## Environmental and Ecological Planning Advisory Committee

The 8th Meeting of the Environmental and Ecological Planning Advisory Committee

**952 Southdale at Col. Talbot Road (northeast corner) EEPAC Review of EIS by MTE dated August 19, 2021 and Hydrogeological Assessment by LDS (LDS) dated August 18, 2021**

## Wetlands

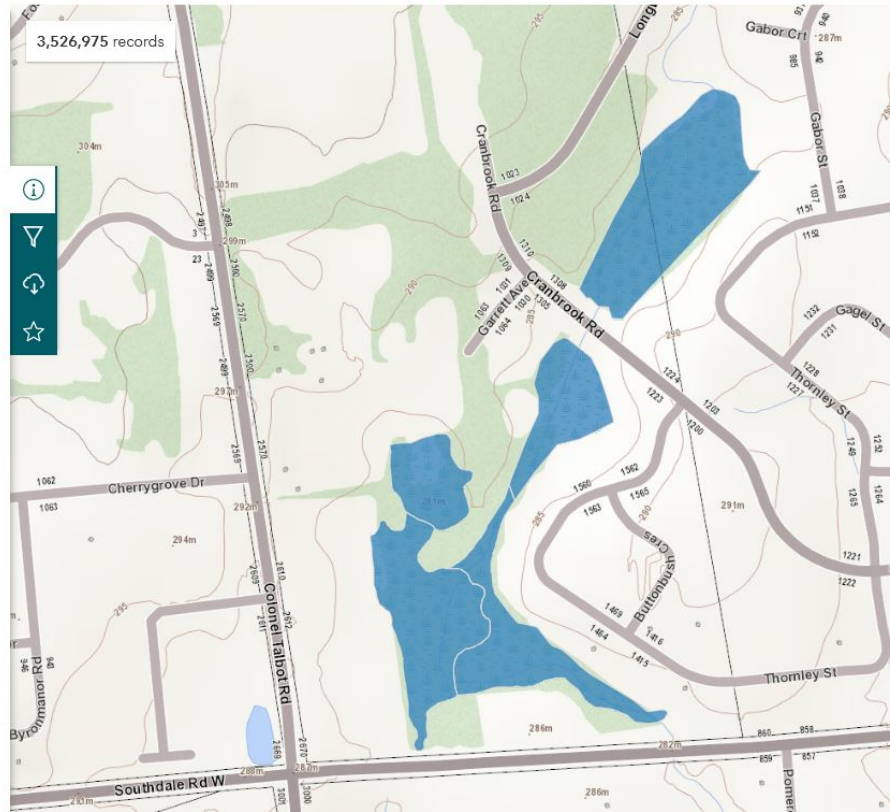
8. The entire PSW is not shown in the air photo figures which is annoying at best and understates the significance of the feature.
9. The full extent of the PSW is noted on Ontario GeoHub (see appendix) and Map 5 of the London Plan. It should be clear to everyone the extent of the PSW.
